bigHead T38/ST38 Head change notification

General guidance material

What is changing?

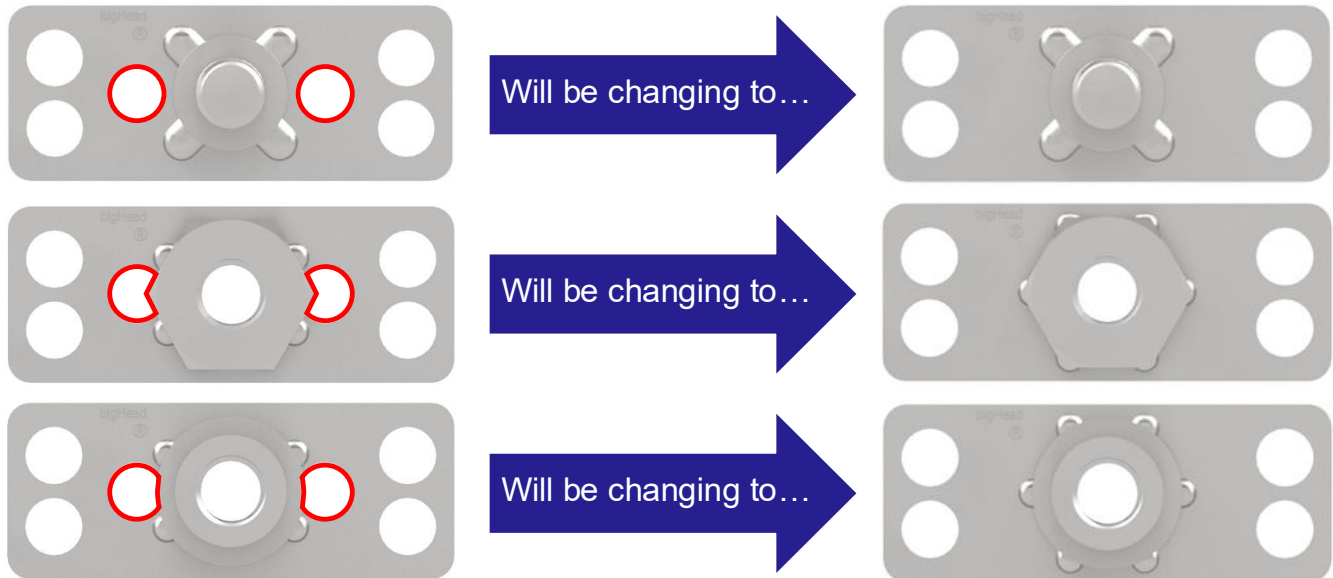
As part of a continuous product improvement program, bigHead is discontinuing the T38/ST38 Head and introducing a new Head design. The inner perforation holes in the T38/ST38 Head (highlighted) will be removed and the new Head will be re-designated T38A/ST38A.

- The performance of the affected bigHead fasteners
- The outer profile and thickness of the Head
- The position of the remaining perforation holes
- The material specifications of the Heads and fixings
- The geometry of the fixings
- The size of any sighted hole in the Head

- Fixture, jiggling or installation strategies that rely on the Head inner perforation holes
- Any design assumptions based on the Head inner perforation holes
